UNITED STATES PATENT AND TRADEMARK OFFICE

APPLICATION NO.	FILING DATE	FIRST NAMED INVENTOR	ATTORNEY DOCKET NO.	CONFIRMATION NO.
10/743,854	12/22/2003	Kunitake Matsushita	31647-5	9104

Office Action Summary

DETAILED ACTION

Fig.2.

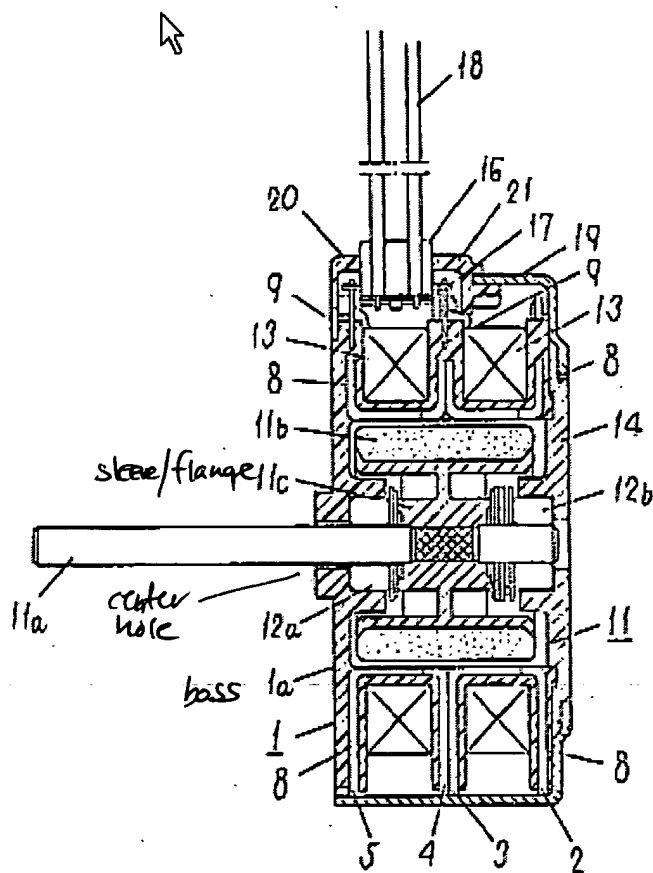
3. Claims 1, 7 and 11-12 are rejected under 35 U.S.C. 103(a) as being unpatentable over Akiba et al. (US 4,714,850) in view of Tanaka (US 4,015,154). With reference to the marked Figure 2 below, Akiba teaches a stepping motor comprising: a rotor 11 including a shaft 11a and a magnet 11b surrounding a portion of the shaft (Fig.2); a stator 1 surrounding the magnet of the rotor with a gap therebetween (not numbered, Fig.2), and adapted to generate a magnetic field thereby causing the rotor to rotate around an axis of the shaft (inherent); a rotor sleeve 11c having a cylindrical portion (not numbered, Fig.2) and a flange (not numbered, Fig.2) provided at one end of the cylindrical portion, the rotor sleeve 11c being provided between the magnet 11b and the shaft 11a so as to fixedly hold the magnet and the shaft together (Fig.2); a boss (holding

part) 1a having a circular shape with a center hole (not numbered; Fig.2) for allowing the shaft 11a to rotatably pass therethrough and being formed (by monolithic resin molding) with the stator 1 (c.3, lines 37-51) so as to oppose the flange of the rotor sleeve (Fig.2); and a bearing 12a rotatably disposed between the boss and flange of the rotor sleeve (Fig.2).

Akiba does not teach ball bearings, per se, for the bearing 12a.
